Comment-Response Document 2014-05

Amendment to Commission Implementing Regulation (EU) No 923/2012 laying down the common rules of the air and operational provisions regarding services and procedures in air navigation (SERA Part C)

CRD TO NPA 2014-05 — RMT.0609 (ATM.001(A)) AND RMT.0610 (ATM.001(B)) — 16.12.2014
RELATED OPINION NO 04/2014

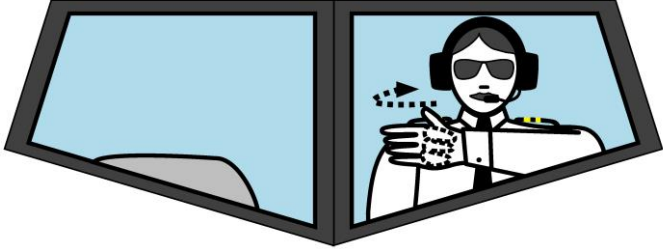
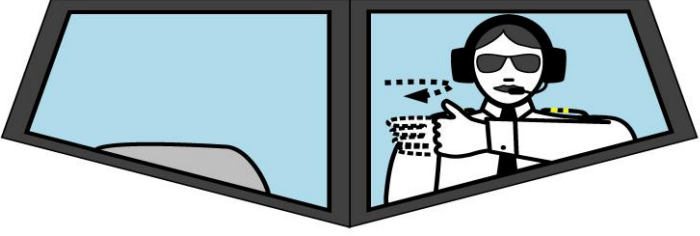
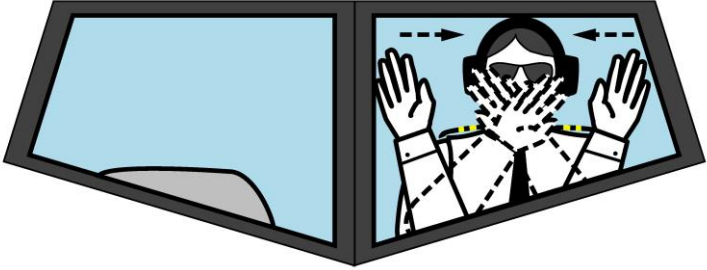
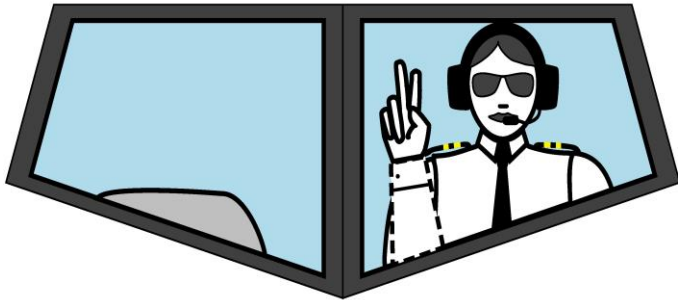
Although it was not part of the proposed amendment, a comment was received proposing to amend Appendix 1 ‘Signals’ by adding some graphics to paragraph 4.2. illustrating signals from the pilot of an aircraft to a signalman/marshaller. It was considered that this proposal increases the clarity and consistency of the rule and is included in the proposed draft rule.

Comment: Although beyond the scope of this NPA, the UK CAA would wish to offer the following graphics, taken from CAP637 Visual Aids Handbook (Table F 'Meaning of Signals made by Pilot to Marshaller (Reference Rules of the Air Regulations Rule 63)) for incorporation in Regulation 923/2012 Appendix 1.

(a) Brakes engaged: raise arm and hand, with fingers extended, horizontally in front of face, then clench fist
	(b) Brakes released: raise arm, with fist clenched, horizontally in front of face, then extend fingers.
	(c) Insert chocks: arms extended, palms outwards, move hands inwards to cross in front of face.
	(d) Remove chocks: hands crossed in front of face, palms outwards, move arms outwards.
